*MWO 11-5820-298-35/1

DEPARTMENT OF THE ARMY MODIFICATION WORK ORDER

MODIFICATION OF RADIO RECEIVERS R-274A/FRR (HAMMARLUND MODEL SP-600-JX), AND R-320A/FRC (HAMMARLUND MODEL SP-600-J) TO PROVIDE MORE ADEQUATE FUSING OF THE POWER TRANSFORMER AND TO PROVIDE BETTER ACCESSIBILITY TO THE B MINUS FUSE

MODIFICATION OF RADIO RECEIVERS R-274A/FRR,
R-274C/FRR, R-320A/FRC, AND THE HAMMARLUND
RADIO RECEIVERS SP-600-JX AND SP-600-JLX,
TO IMPROVE SIGNAL-TO-NOISE RATIO ON AGC OR
MGC OPERATION AND TO PREVENT BLOCKING OF
THE FIRST MIXER TUBE

Figure 9. Modified circuit diagram of receiver.

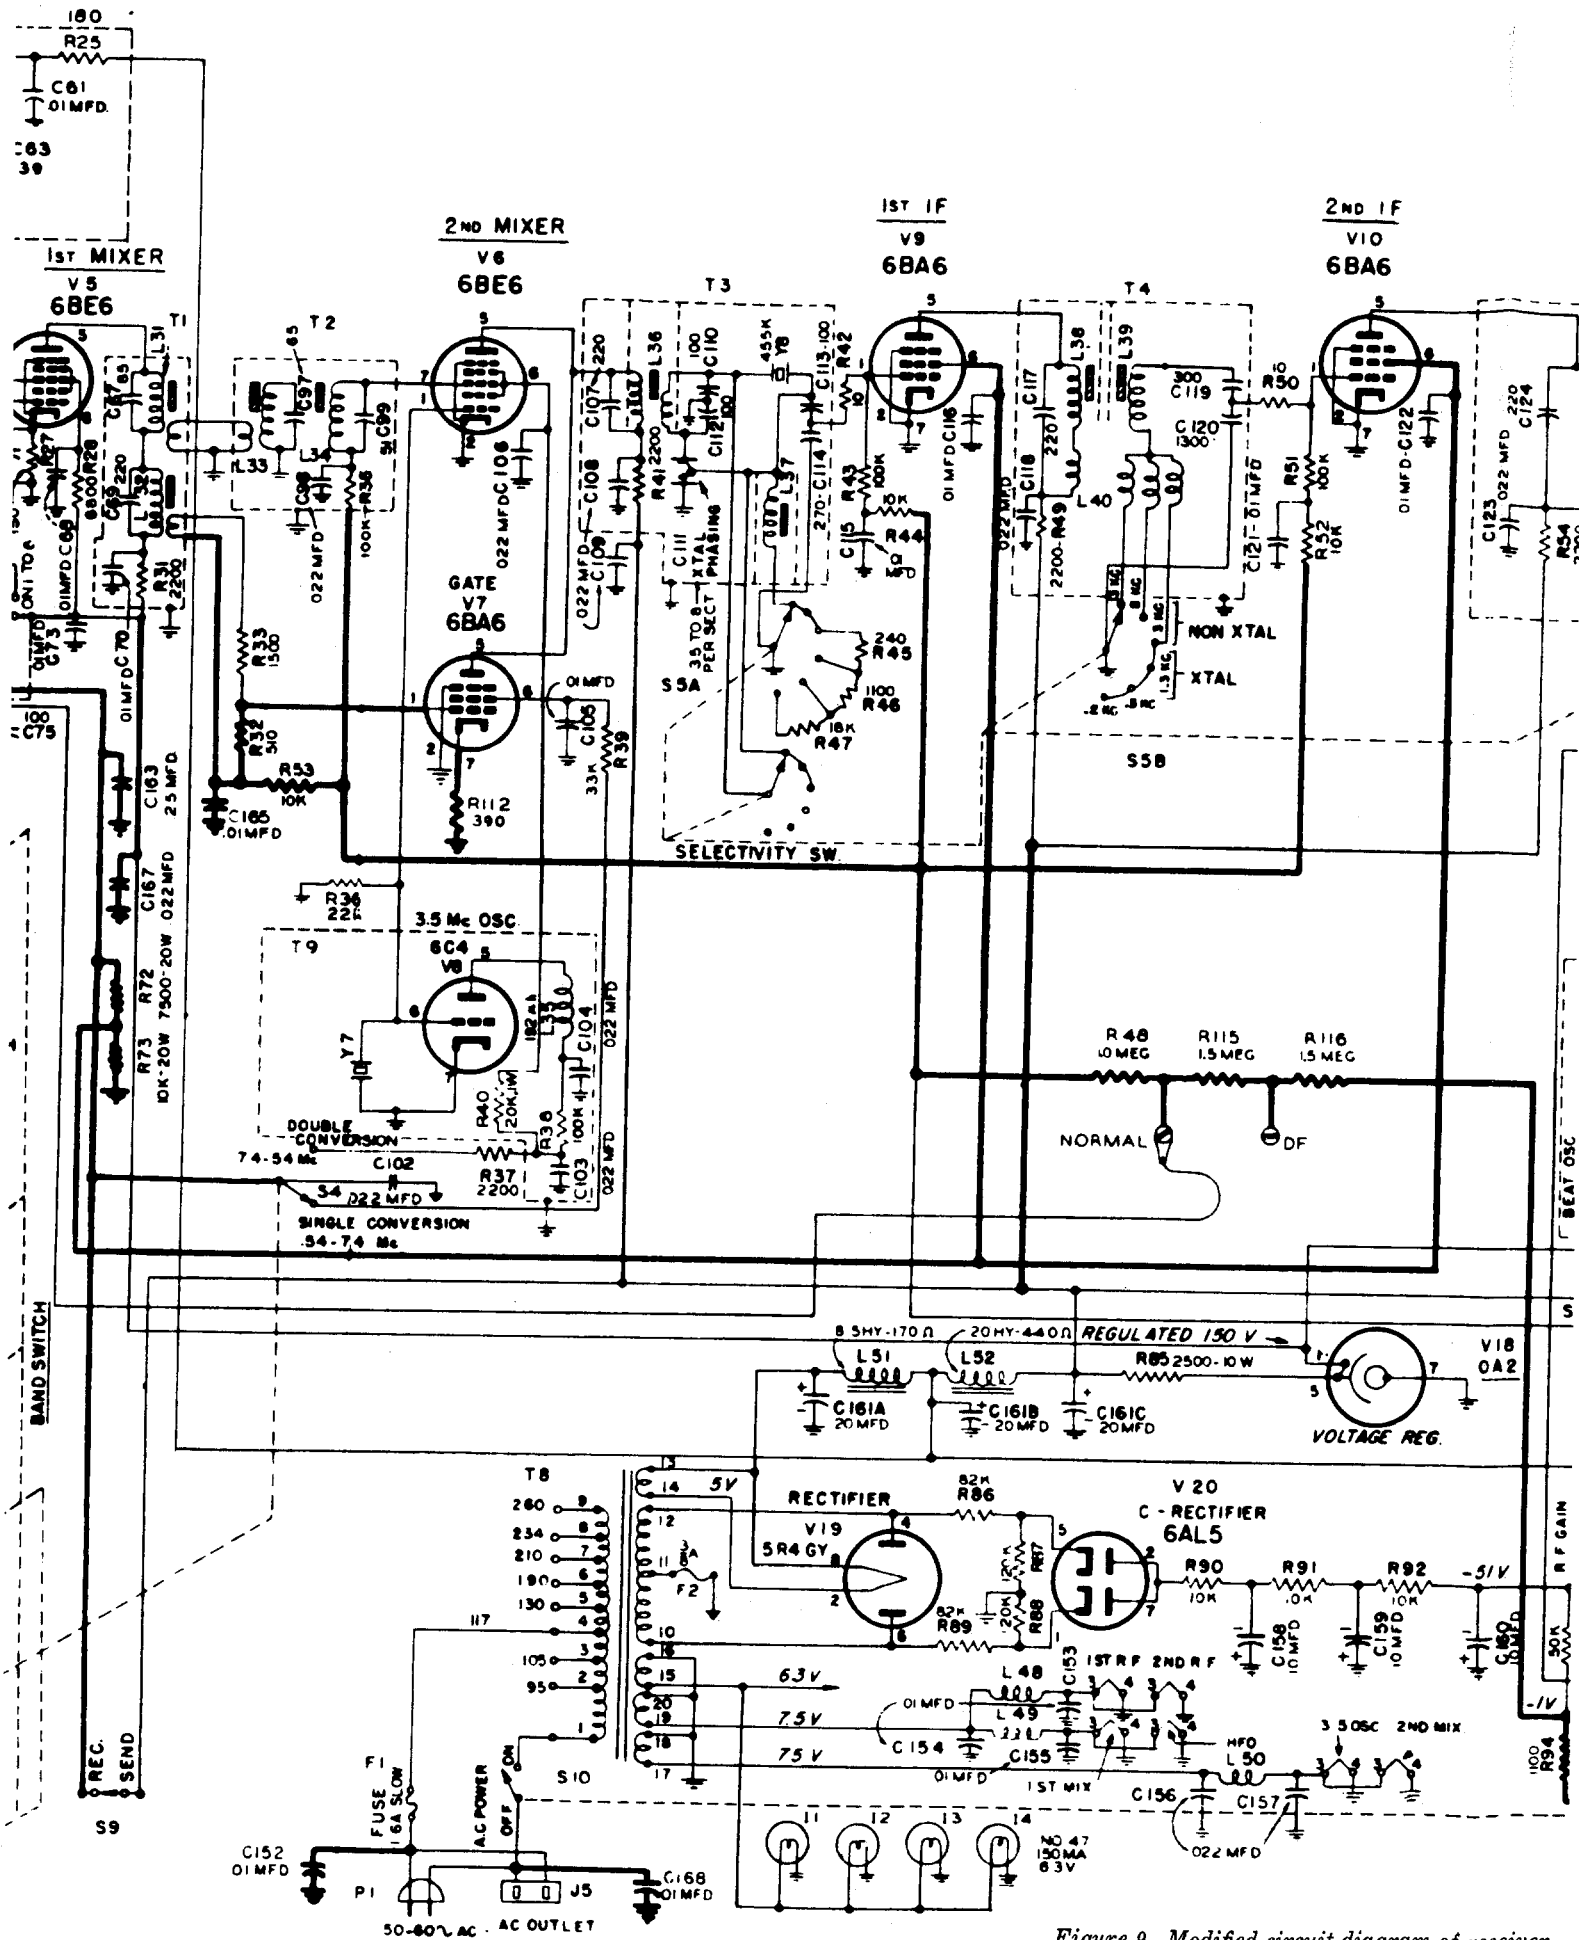
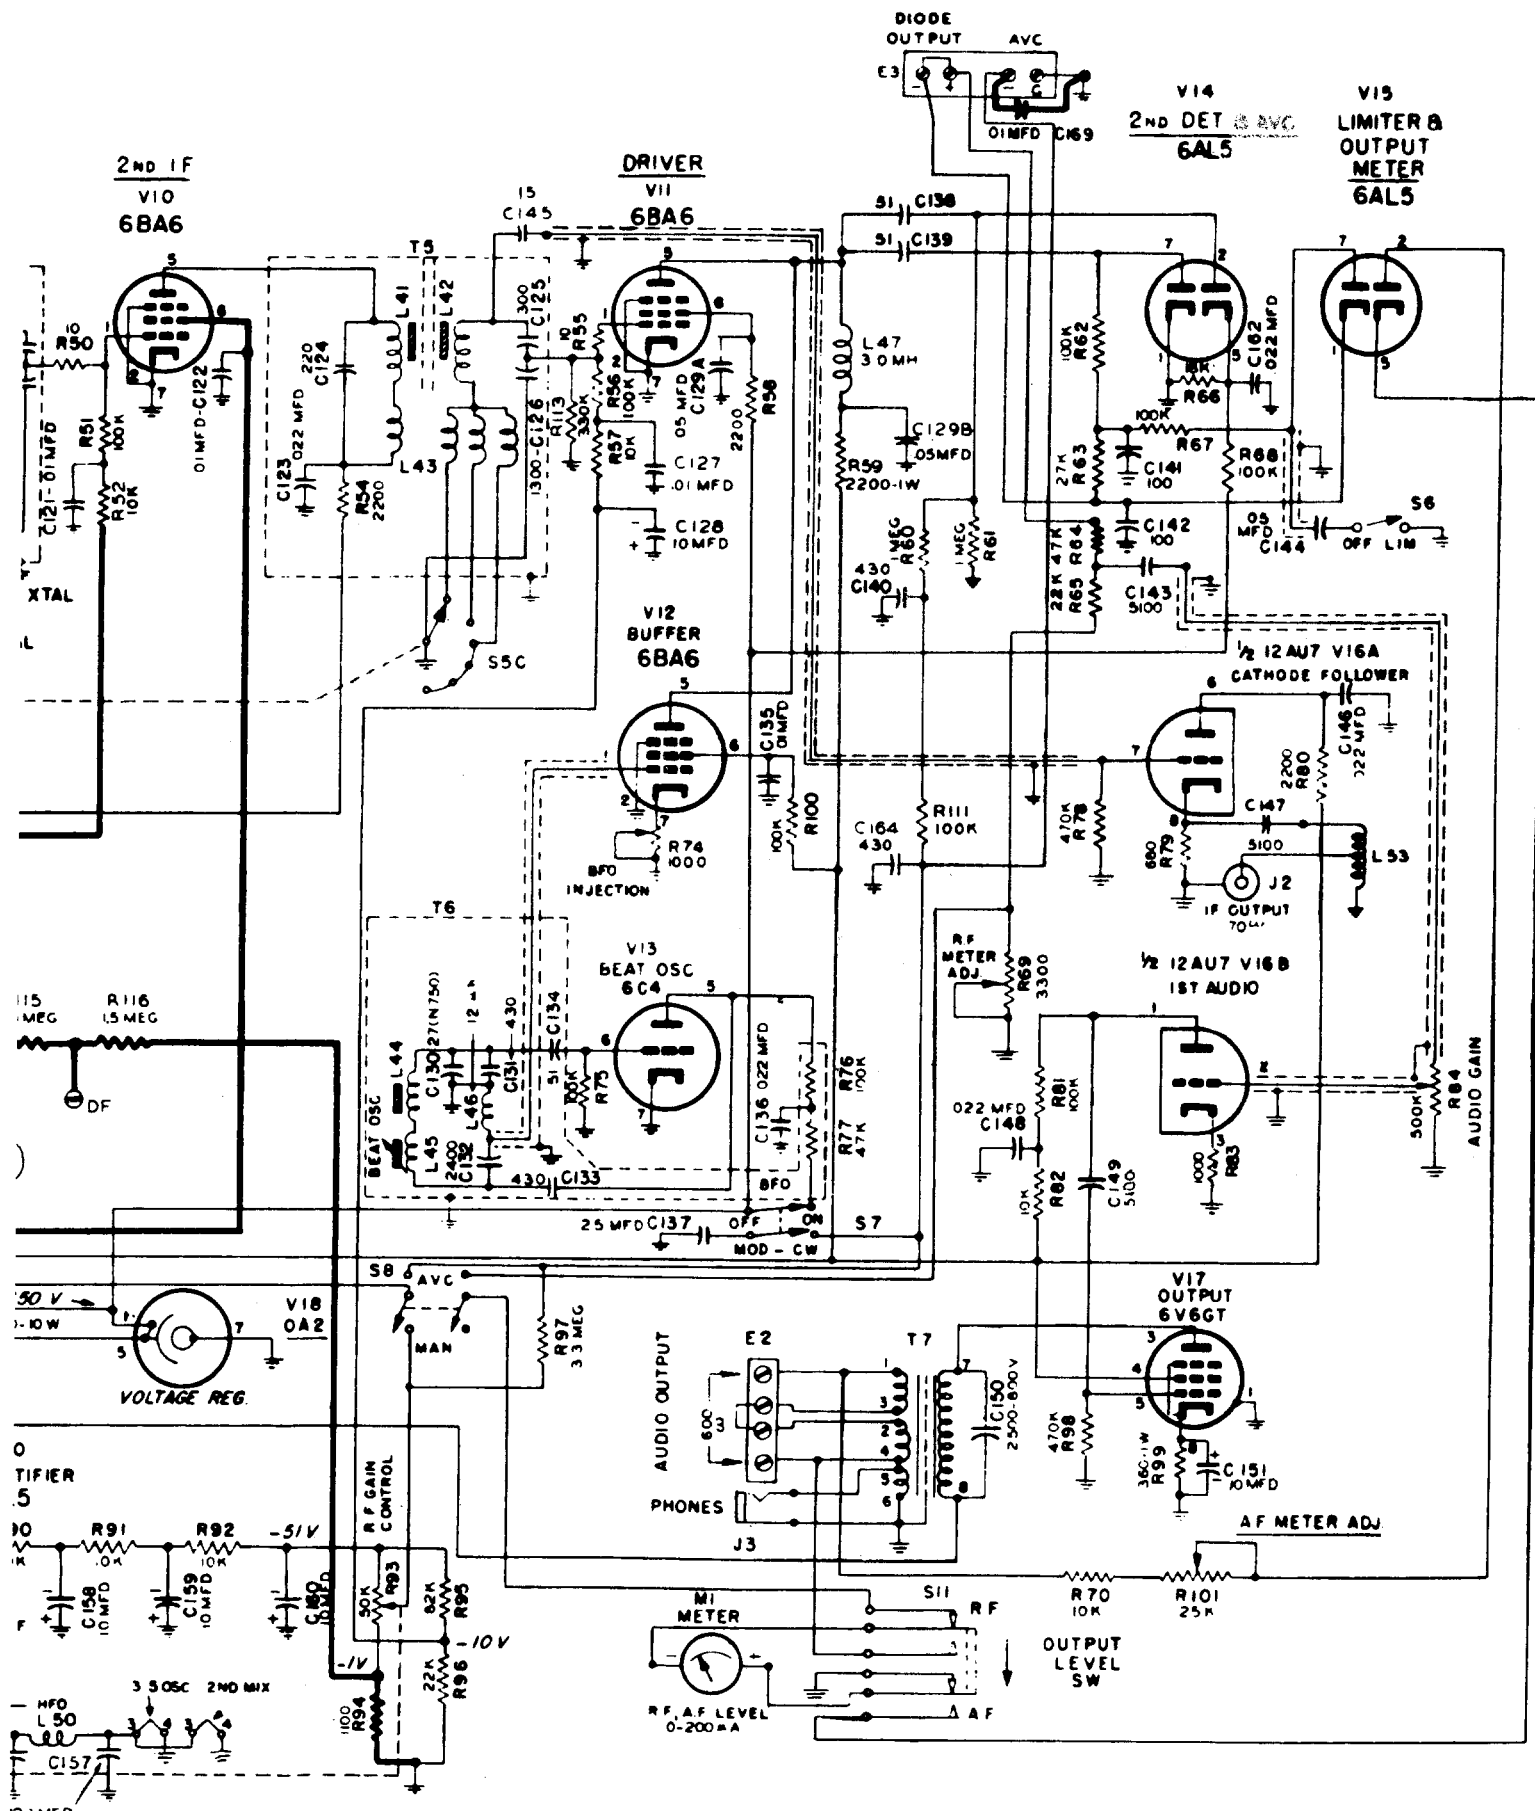
NOTE: HEAVY LINES DENOTE MODIFICATION.

Figure 11. Installation of new resistors in RF interstage subassemblies.

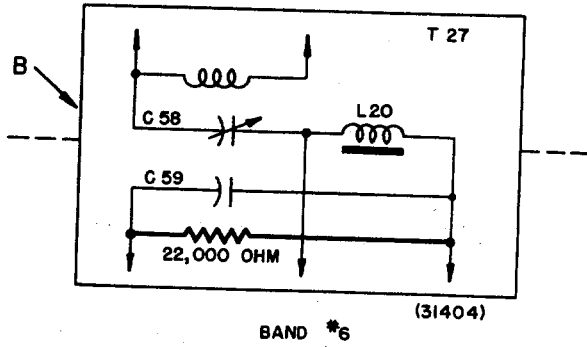
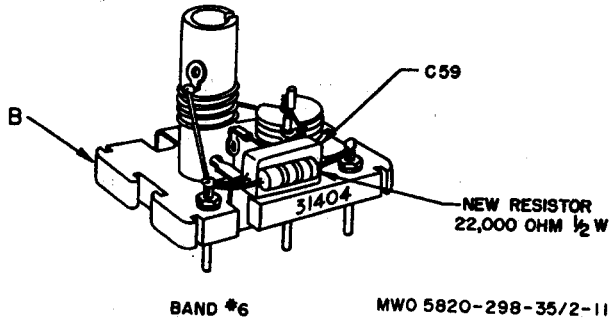
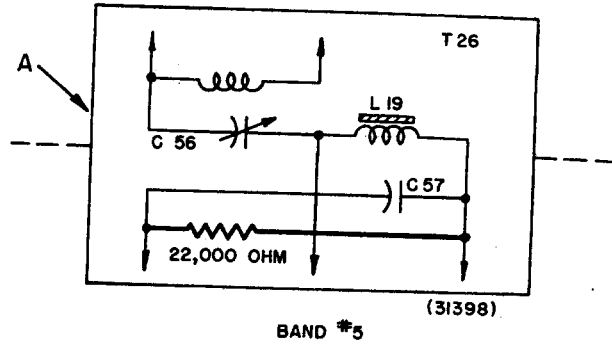
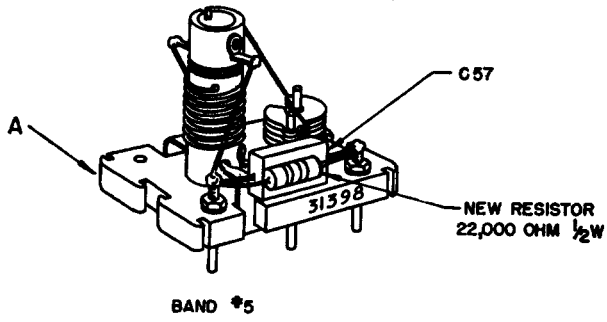
- (4) Connect and solder a 22,000-ohm, 1/2-watt resistor across capacitor C57 in the RF interstage subassembly for band 5, as shown at A, figure 11.
- (5) Check the wiring for conformity with the diagram at A, figure 12.
- (6) Connect and solder a 22,000-ohm, 1/2-watt resistor across capacitor C59 in the RF interstage subassembly for band 6, as shown at B, figure 11.
- (7) Check the wiring for conformity with the diagram at B, figure 12.
- (8) Replace the RF interstage subassemblies for bands 5 and 6 to the RF tuning unit rotary turret in their original position, using the original flat springs.
- (9) Replace the bottom cover to the tuning

Figure 2. New locations of resistors R72 and R73 and capacitors C152 and C168.

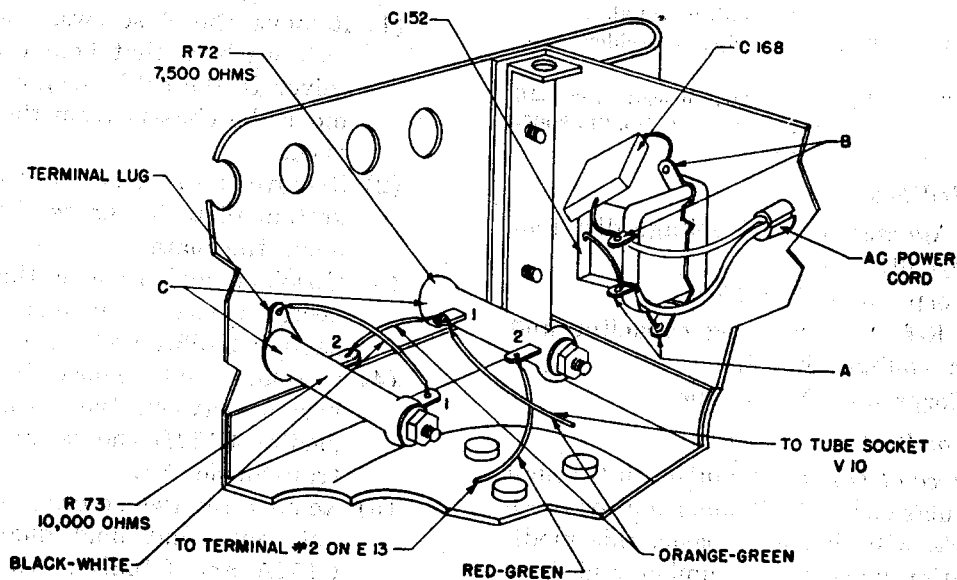
- (1) Mount a new 10,000-ohm wire-wound resistor (R73); use a No. 6-32 x 2 1/2-inch long round head steel screw, washers, nut, solder lug, and the existing hole originally used to mount one side of dual capacitor C152 and C152B, as shown at B, figure 1, and in the position shown at C, figure 2.
- (2) Mount a new 7,500-ohm wire-wound resistor (R72); use a No. 6-32 x 2 1/2-inch long round head steel screw, washers, nuts, and the existing hole originally used to mount one side of dual capacitor C152A and C152B, as shown at B, figure 1, and in the position shown at C, figure 2.
- (3) Connect and solder a suitable length of black-white wire between terminal No. 1 of resistor R73 and the terminal lug as shown in figure 2.
- (4) Connect and solder a suitable length of orange-green wire between terminal No. 1 of resistor R72 and terminal No. 2 of resistor R73, as shown in figure 2.

- (5) Unsolder and remove resistor R48 (33,000 ohms) connected between pin No. 6 of tube socket V9 and terminal No. 4 of terminal board E17.
- (6) Unsolder and remove resistor R53 (33,000 ohms) connected between pin No. 6 of tube socket V10 and terminal No. 11 of terminal board E17.
- (7) Connect and solder a suitable length of orange-green wire between pin No. 6 of tube socket V9 and Pin No. 6 of tube socket V10 as shown at A, figure 3.
- (8) Connect and solder a suitable length of orange-green wire between pin No. 6 of tube socket V10 and the junction of resistors R72 and R73 as shown in figure 2.

Page 4. Figure 2. Make the following change in figure 2: At the end of the "RED-GREEN" lead connected to terminal 2 of R72, change "TO TERMINAL #2 ON E13" to read: TO TERMINAL #1 ON E13.

Figure 3. New component and wiring changes at terminal strip E17.

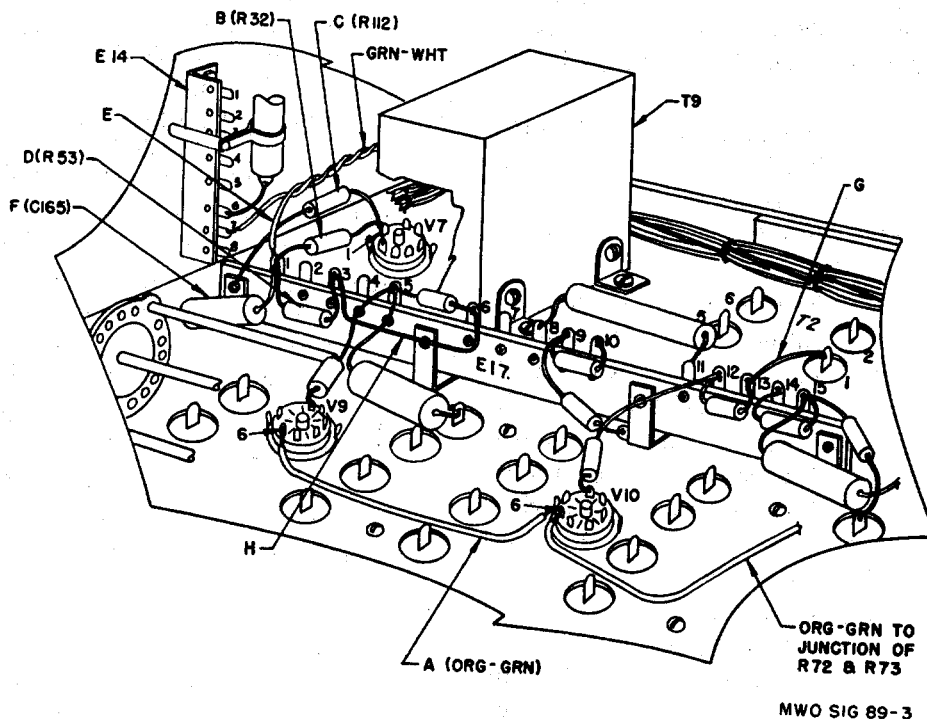
(2) In some receivers, pin No. 7 of V7 is ground. Remove the ground leads, and connect and solder a 390-ohm resistor (R112) between pin No. 7 of V7 and the ground terminal of E17 (C, fig. 3).

(3) Connect and solder a 10,000-ohm resistor (R53) between terminals No. 1 and No. 3 of terminal board E17 as shown at D in figure 3, where this resistor does not already exist or is of a value other than 10,000 ohms.

(4) Unsolder and remove the green-white wire from terminal No. 8 (ground lug) of terminal board E14, and connect and solder this lead to terminal No. 1 of terminal board E17 (E, fig. 3).

(7) Connect and solder a suitable length of white-black wire between terminal No. 1 of transformer T2 and terminal No. 13 of terminal strip E17, as shown at G in figure 3.

Figure 5. Lead connections to new terminal board E13.

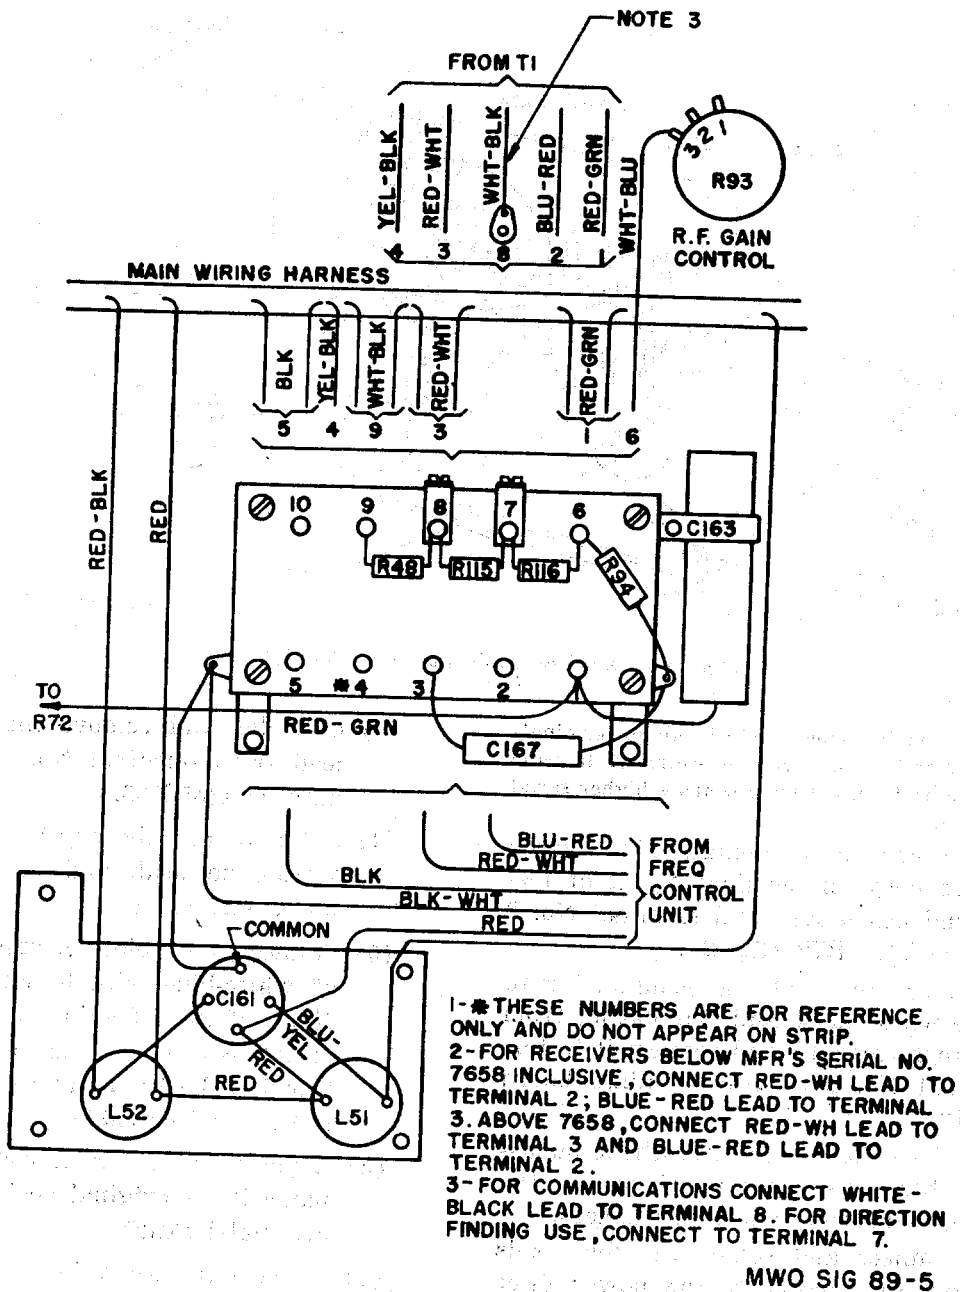
(10) Connect and solder the wires removed from the old terminal strip to the new terminal board in accordance with figure 5.

Note. For receivers with serial numbers, below manufacturer's serial No. 7658 inclusive, connect red-white and blue-red leads

from the frequency control unit to terminals No. 2 and No. 3 of E13 respectively. Reverse these leads on receivers bearing higher serial numbers.
